PCN No#: 080622-1

PCN Title: ITO-220 Series Package Pin Dimension Change

## PRODUCT CHANGE NOTICE

**Table A - "E" Dimension Comparison**

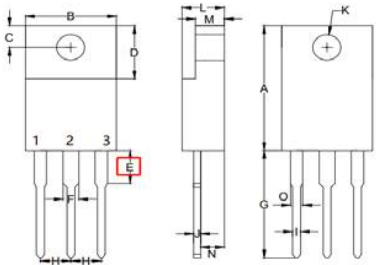
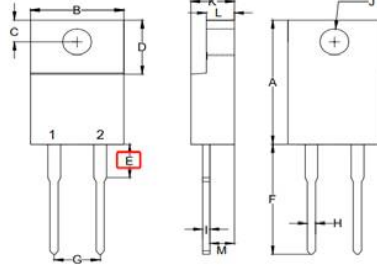
Notification Date	Implementation Date	Change Type	Classification	PCN No
Aug 06, 2022	Feb 06, 2023	Pin Dimension Change	Major	080622-1
TITLE				
ITO-220 Series Package Pin Dimension Change				
DESCRIPTION OF CHANGE				
This PCN is being issued to notify customers that In order to improve the versatility of products, better convenient for customers to use. MCC decides to adjust the "E" Dimension of ITO-220 Series Package. Full electrical characterization and reliability testing has been completed and the result showed that the parts had the same performances as the parts we shipped before.				
IMPACT				
No change in datasheet electrical parameters and product performance. Table A: Comparison of Package Dimension				
PRODUCTS AFFECTED				
See Table B for Product list				
WEB LINKS				
Terms And Conditions:	<a href="https://www.mccsemi.com/Home/TermsAndConditions">https://www.mccsemi.com/Home/TermsAndConditions</a>

Dimension Before Change	Dimension After Change	Dimension Before Change	Dimension After Change
3.75mm	3.25mm	3.75mm	3.25mm
